CLARIFICATIONS FOR 5940500 – SUPPLY AND INSTALLATION OF THE PRIMARY SUBSTATIONS INTERCONNECTING CIRCUITS FOR KORLE-GONNO, KOTOBABI, KANDA AND LEGON

CB NO: 5940500/IFB/CB/06/19

EQUIPMENT ELEVATION

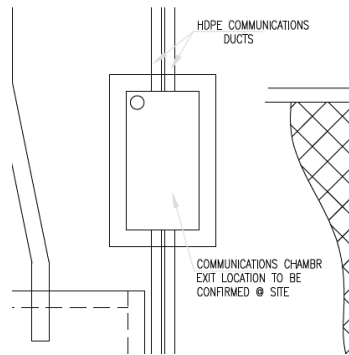
Please confirm that we have to provide a concrete plinth and a fence for the Two (02) RMUs seen on the screenshot from the "Single line diagram 11kV offloading circuits - UGTH" even if we only have drawings for 1, 3, 4 and 5 RMUs.

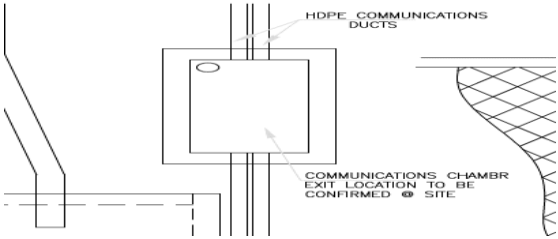
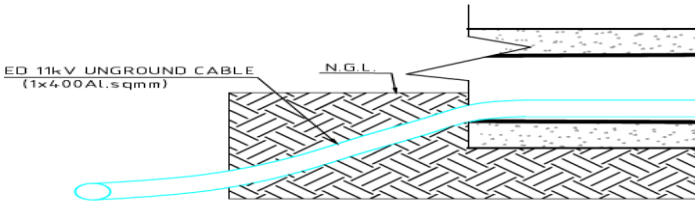
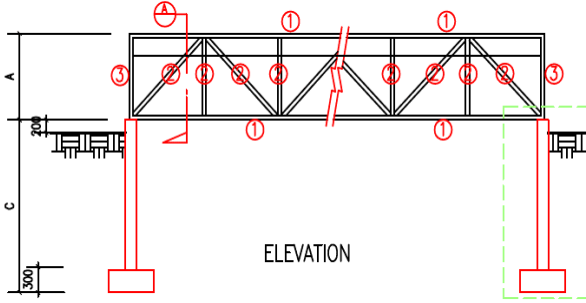
Please specify which value of Span/length is to be considered; the value indicated on the table or the value of the CAD plan. we have a span of 4200m but in the plan we have a length of

As per Table – 4 - Employers Technical requirement Volume II.
